**CERTAIN 2015-MODEL FJ09F(C), FZ09F(C), FZ6RF(C), XTZ12F(C), XTZ12EF(C), AND YZFR6F(C)  
Factory Modification Campaign – Shift Shaft Failure**

**INTRODUCTION**

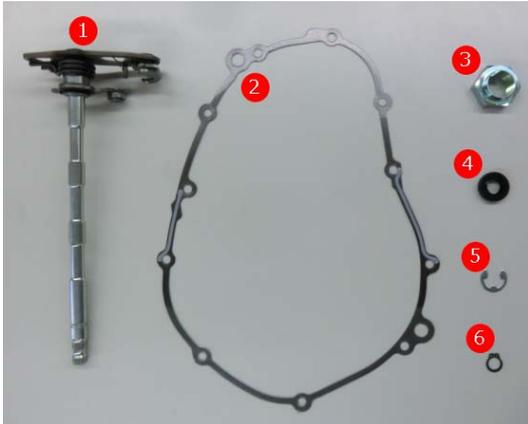
After modifying a unit, make sure to properly record and submit the warranty claim for this safety recall to ensure not only correct reimbursement but also to update the unit's repair history in Yamaha data base. Perform a unit status inquiry in YDS to check if the unit is in the affected range or if the unit has been modified. A modified unit can also identified by the blue paint mark on the end of the shift shaft.
